BL417 Geological Sciences Phase 2 F100 IGWS East
(F100) Lab Renovations
IU 20250361

ADDENDUM NO. 2
14217

20 March 2026

SECOND FLOOR - EAST WING - ELECTRICAL DEMOLITION PLANS
E102

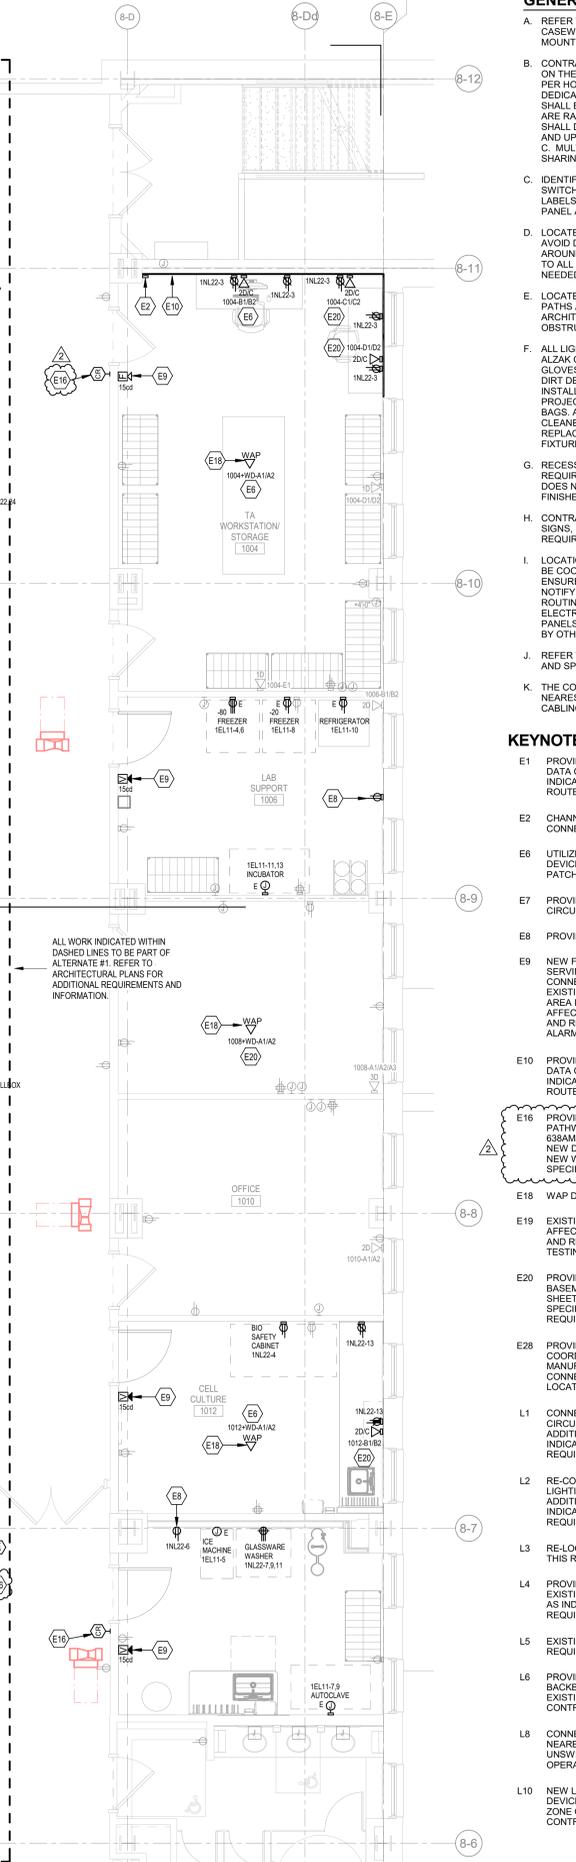
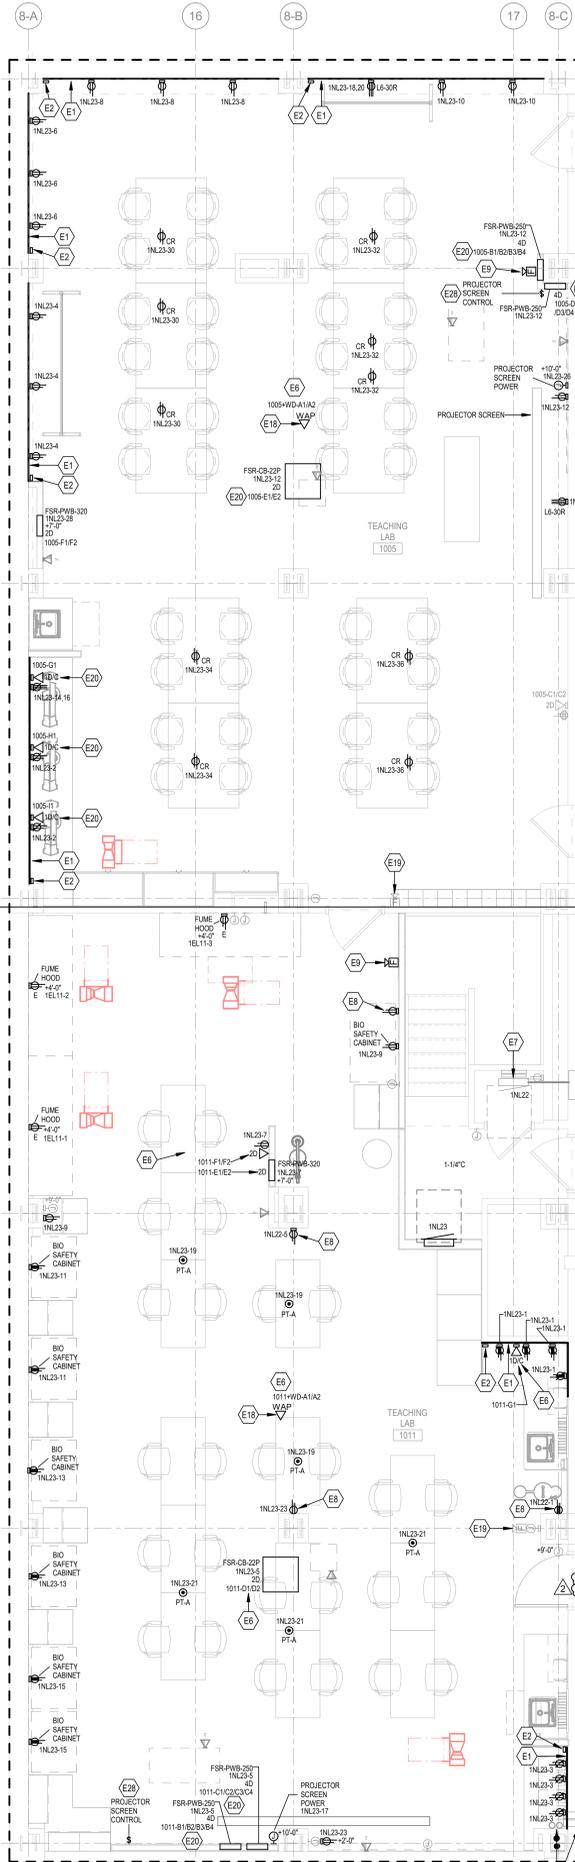
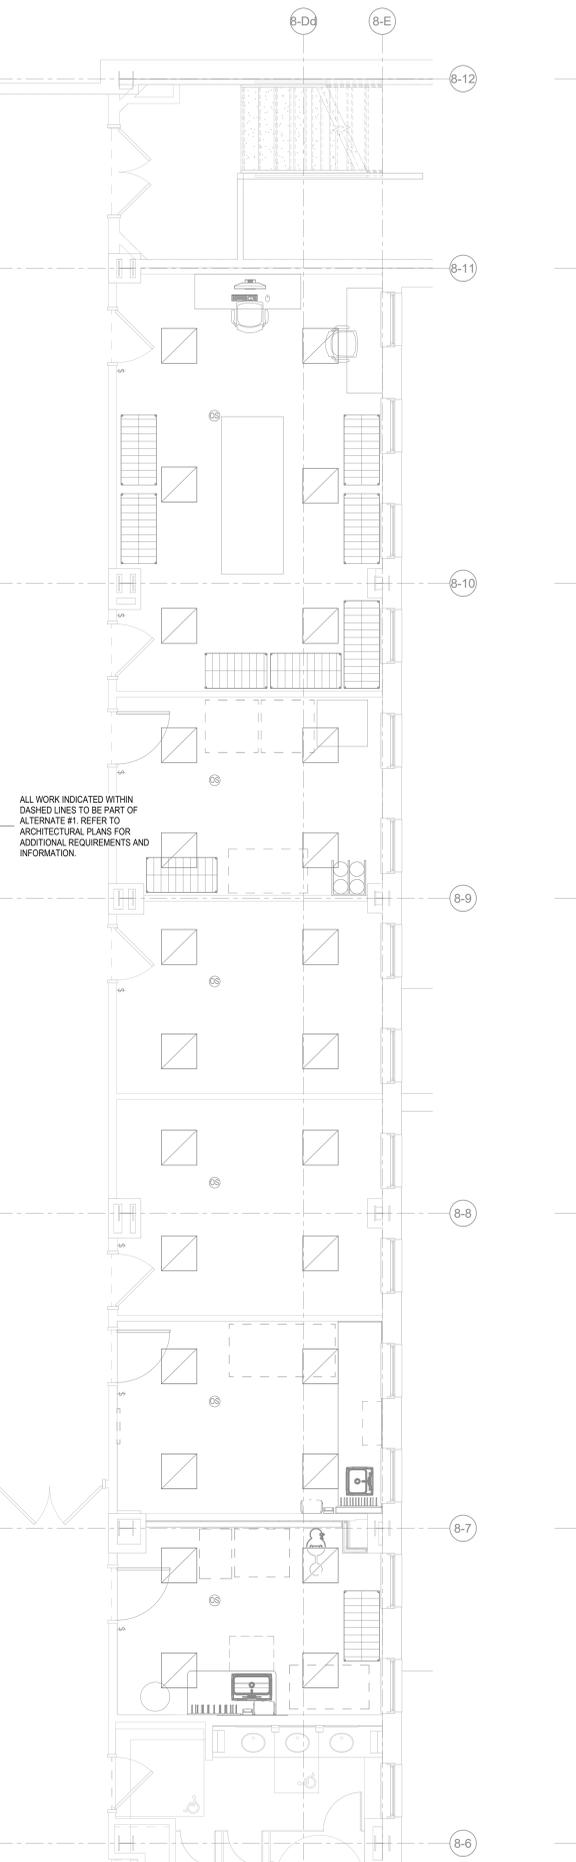
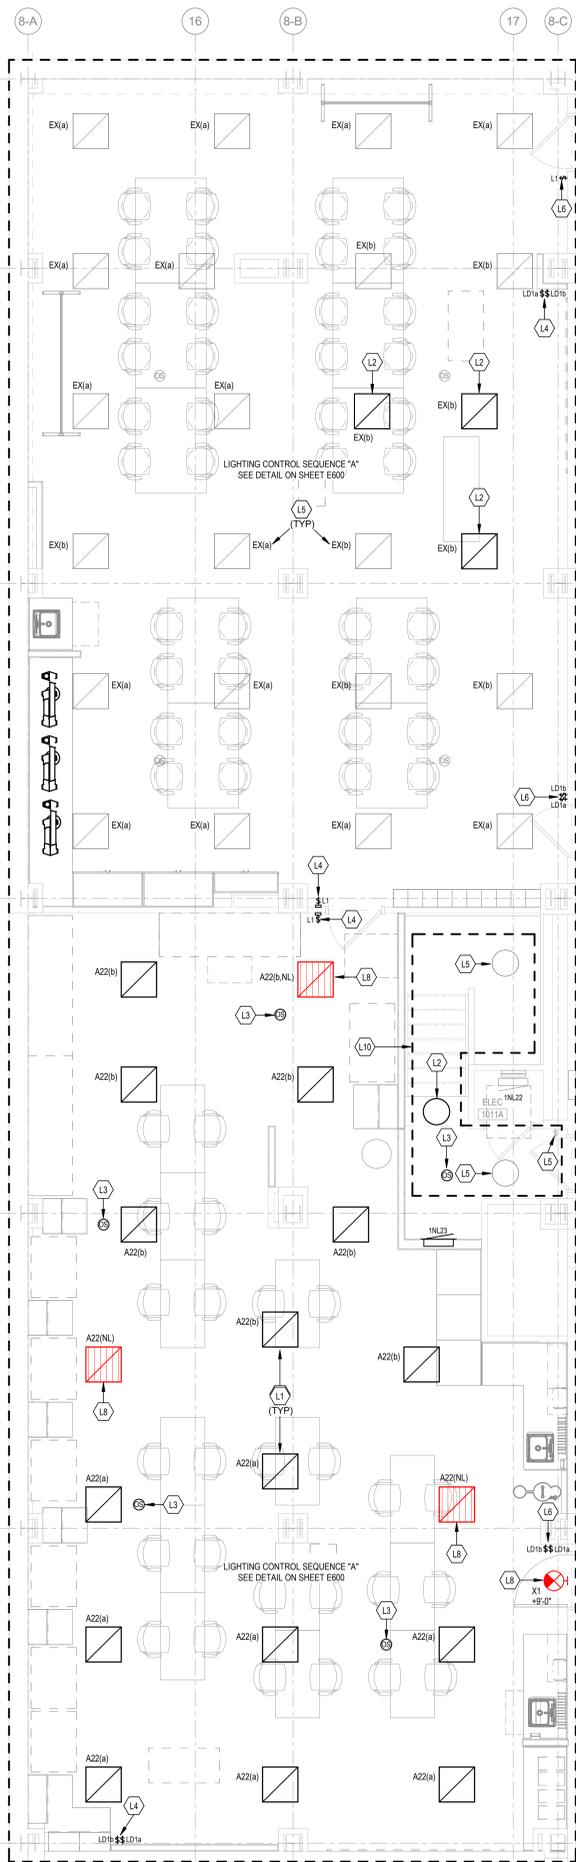
- e. Modified plan notes.
3. Sheet E102 – SECOND FLOOR - EAST WING - ELECTRICAL DEMOLITION PLANS
 - a. Revised tagged note #D12 for fire alarm system work.

THIRD FLOOR - EAST WING - ELECTRICAL PLANS
E203

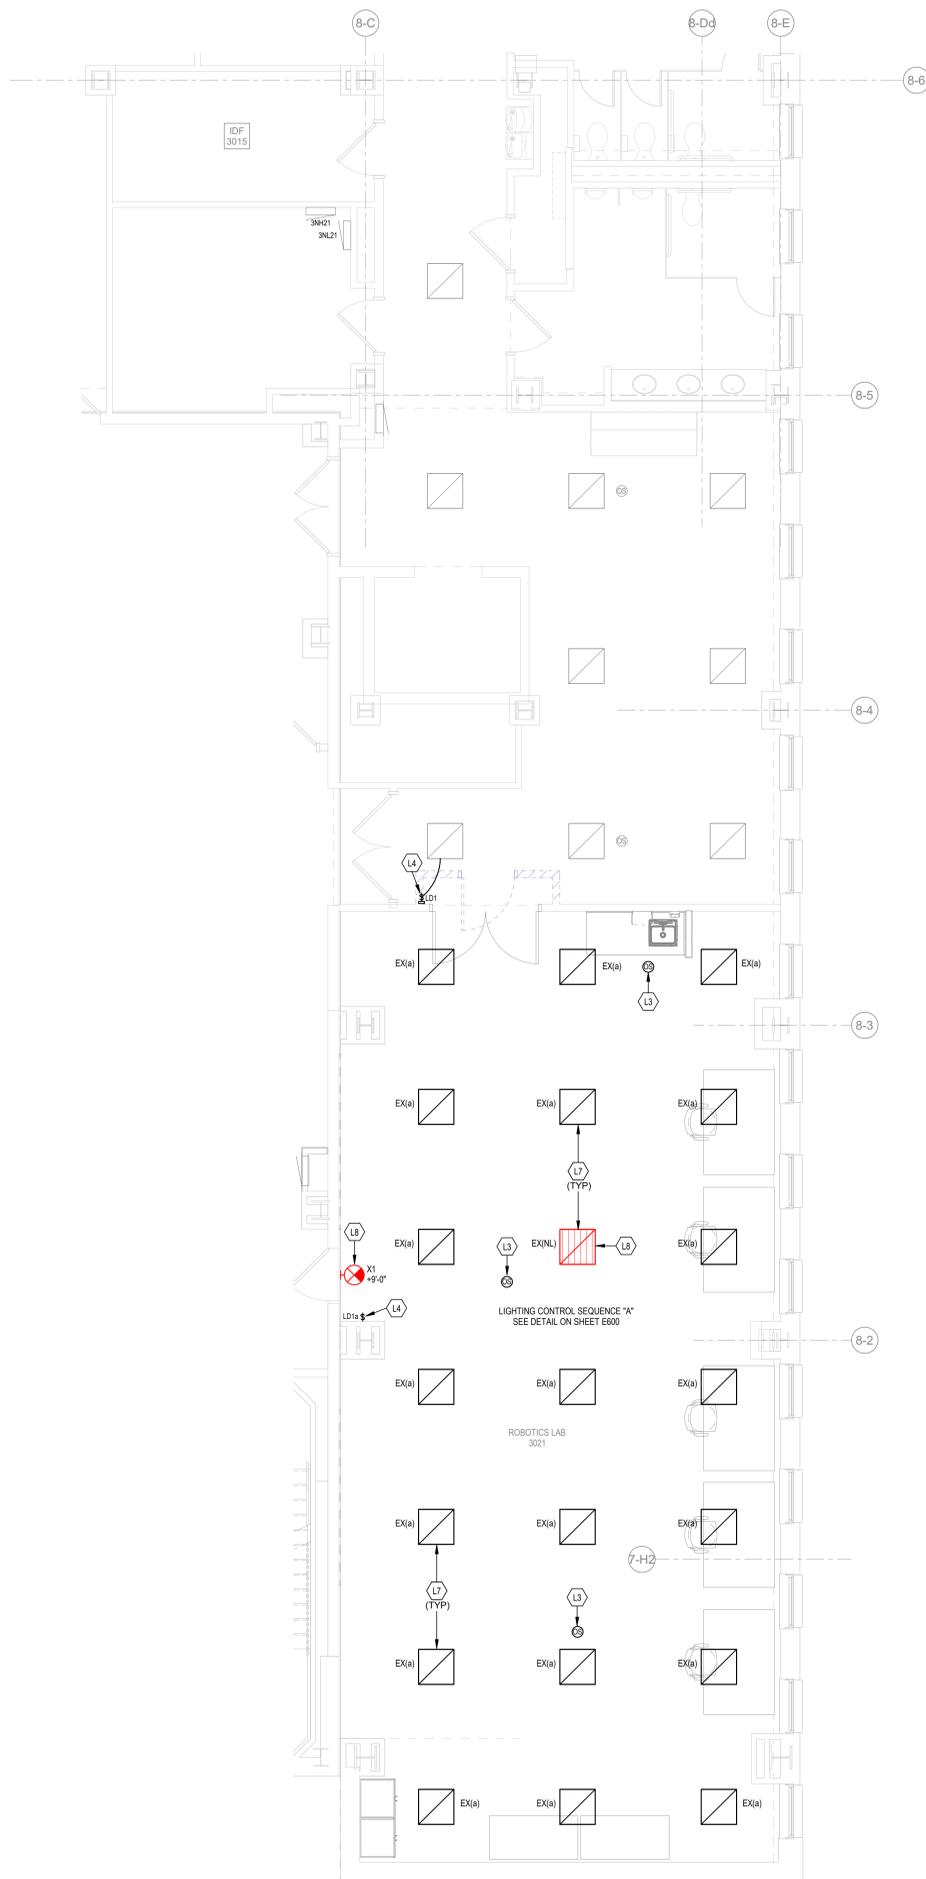
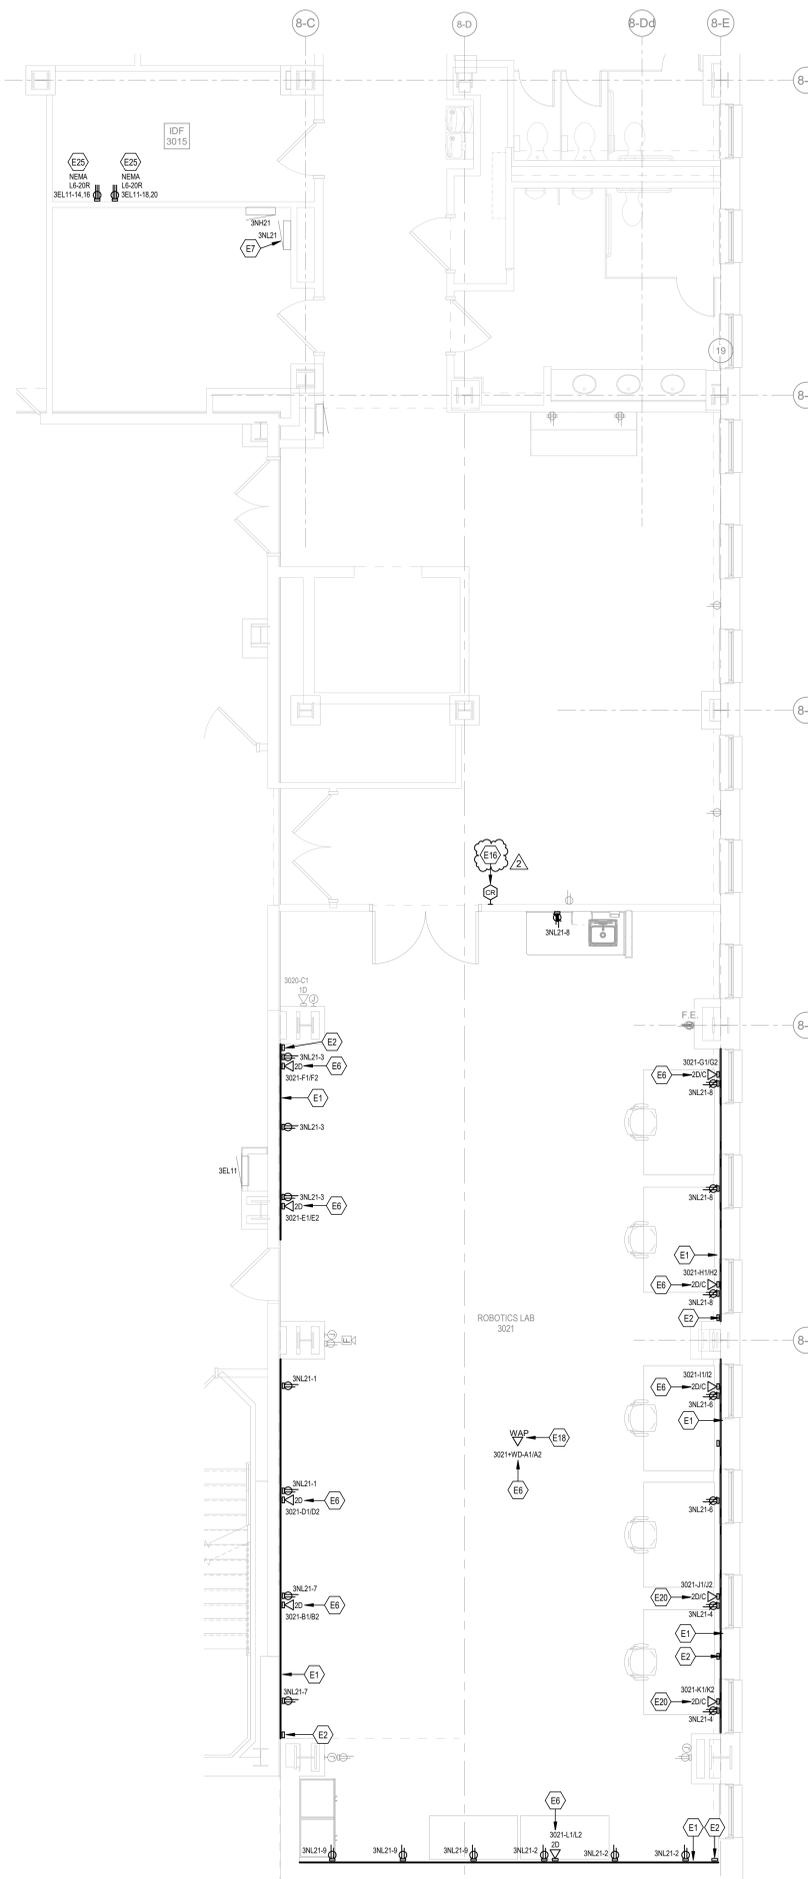
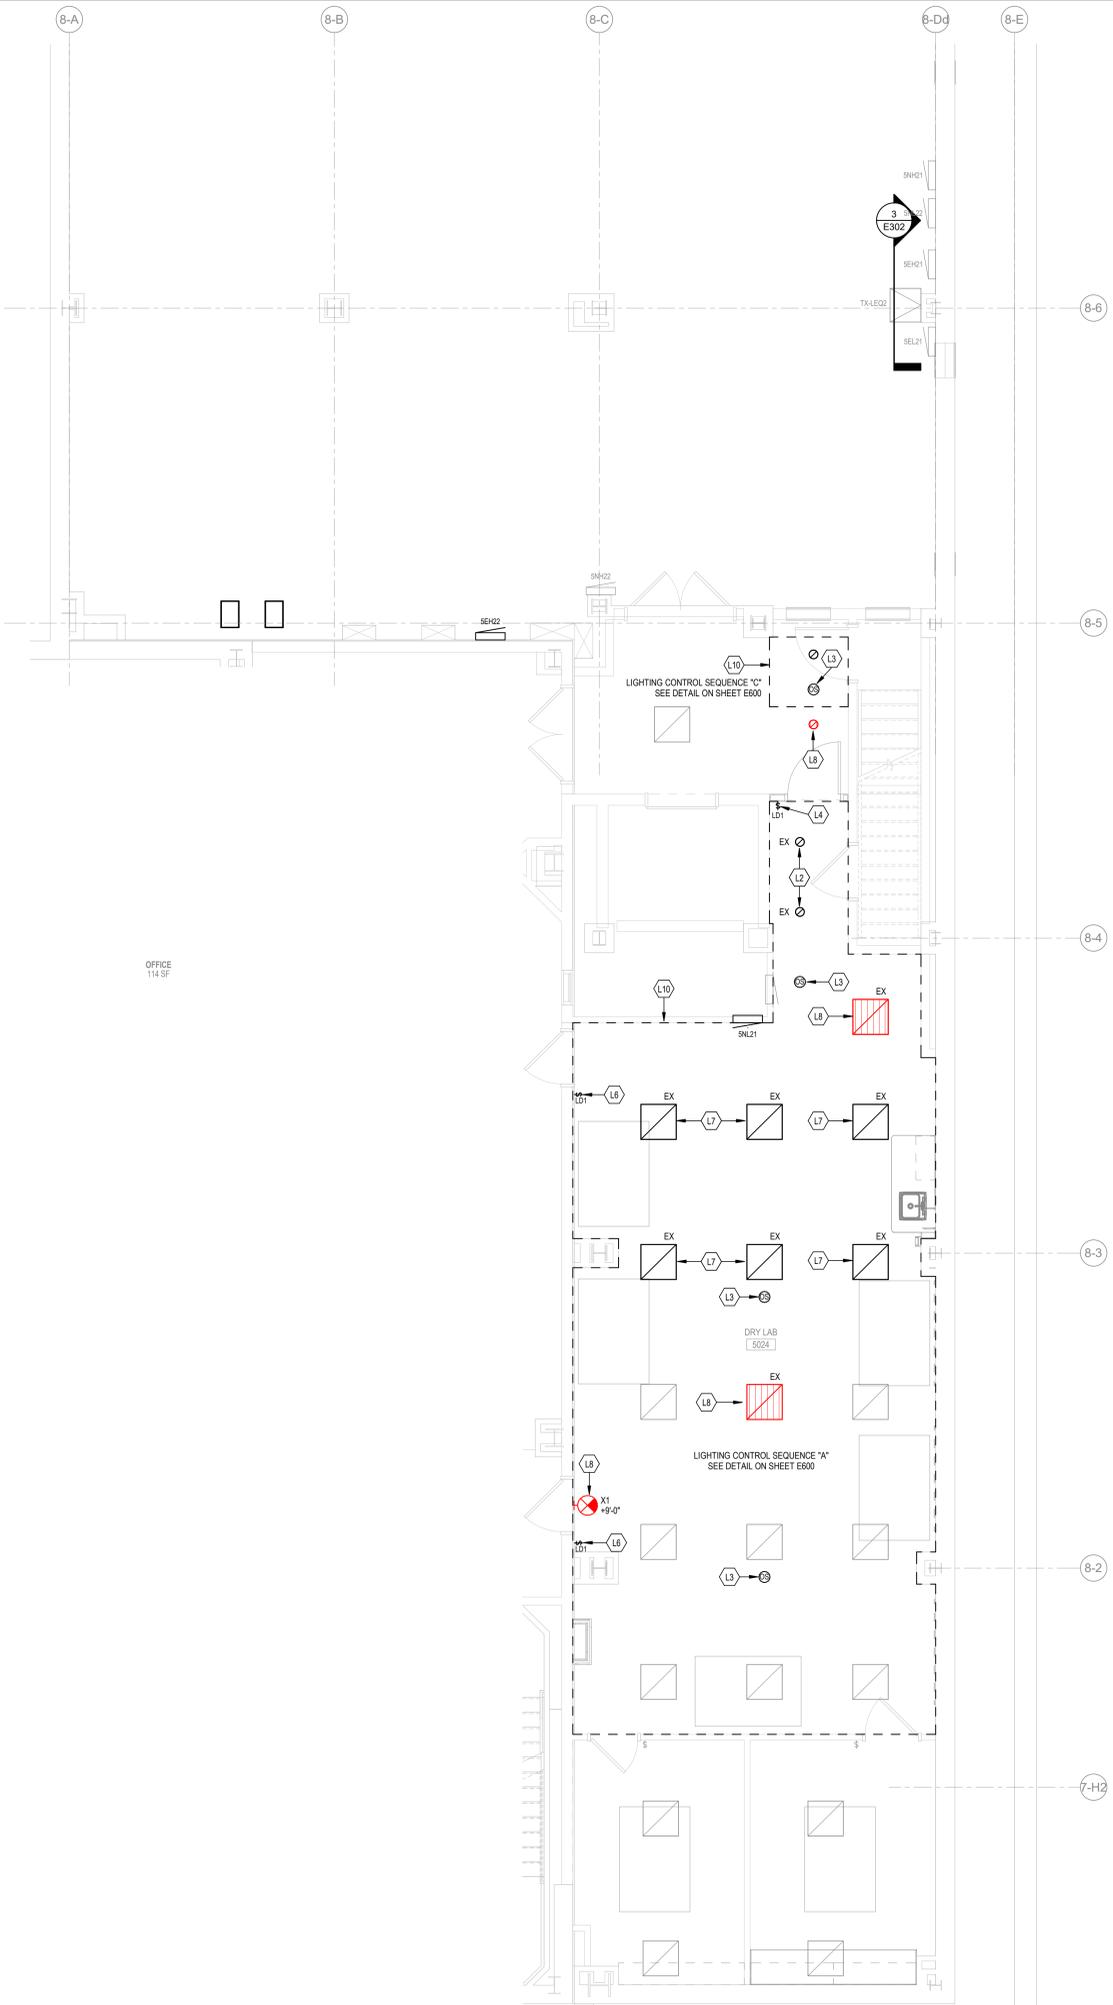
- c. Power connection added for new door access controls equipment.
6. Sheet E203 – THIRD FLOOR - EAST WING - ELECTRICAL PLANS
 - a. Revised tagged note #E16 for access controls work.
